REVISION TO DRAWINGS – TECHNICAL DRAWINGS PROVIDED BY CERTA BUILDING SOLUTIONS

END OF ADDENDUM 1

VERN PATRICK ELEMENTARY ROOFING PROJECT

OR25-005 VERN PATRICK - ROOF REPLACEMENT

ROOF PLAN
A300

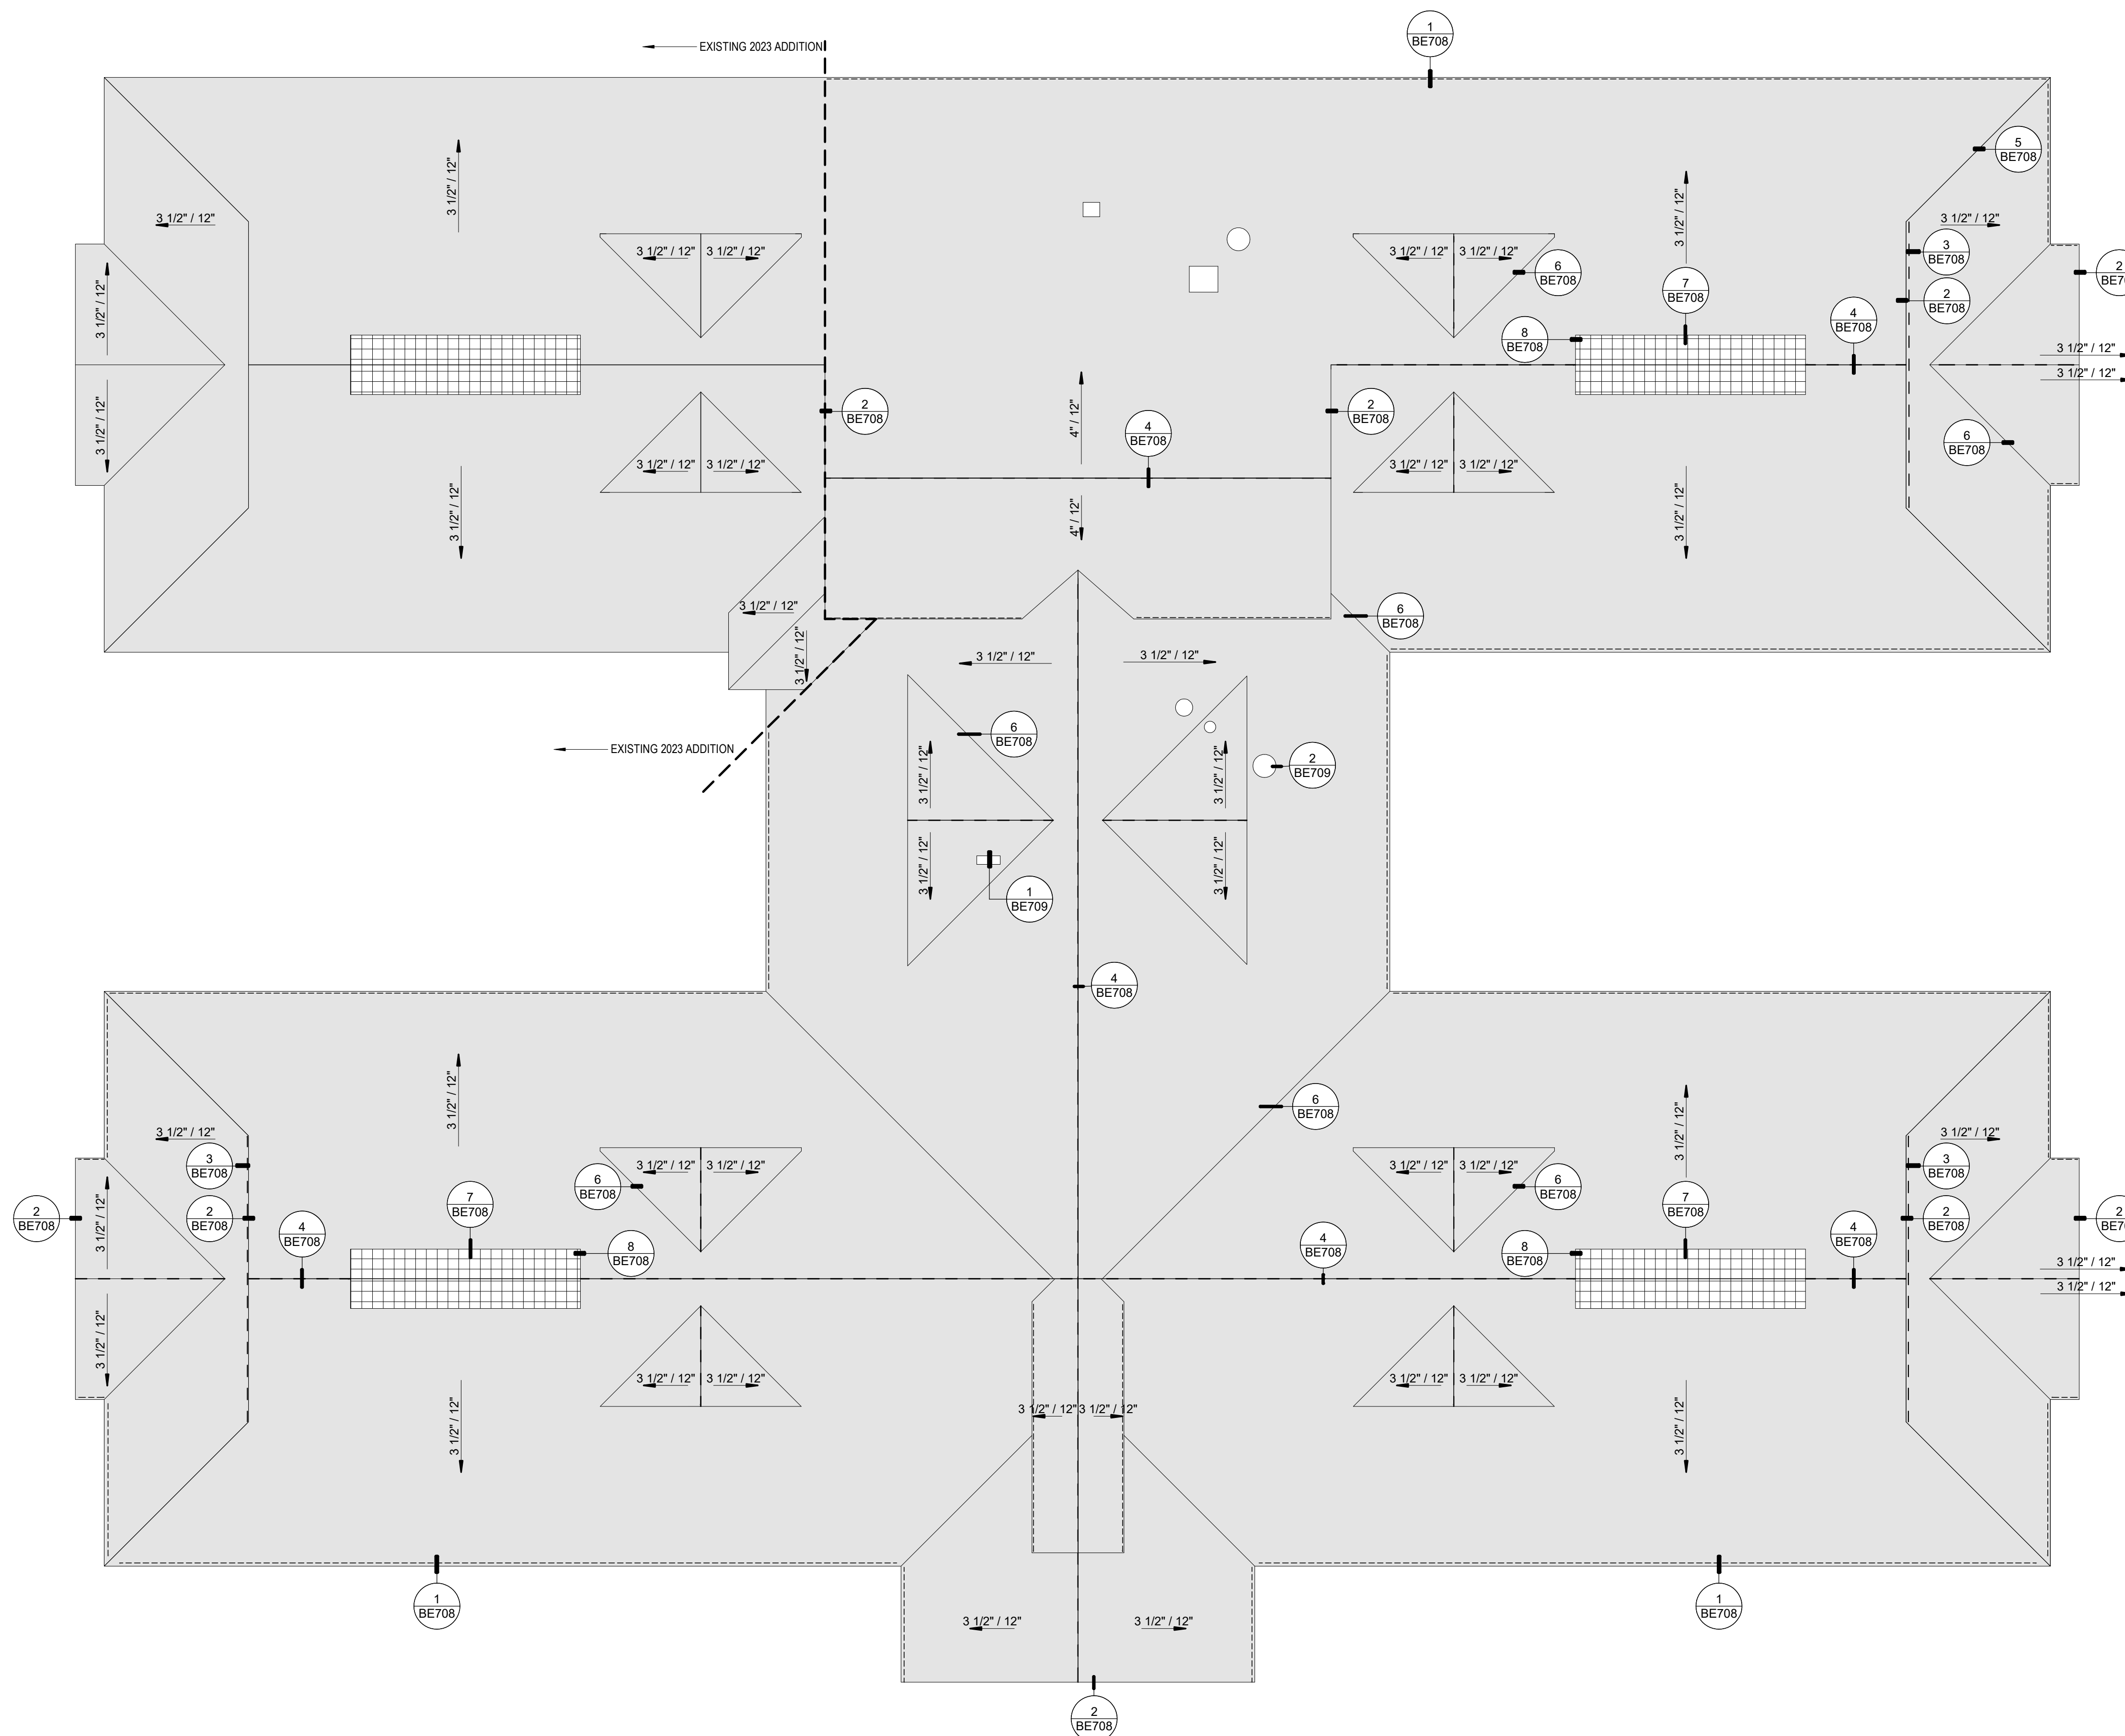
1. A300 – Scope of Repair Notes – removed 5
2. BE708 – Alternate added. Alternate was not clouded but should be: 07 62 00 – Sheet Metal Gutter
3. BE709 – Details added
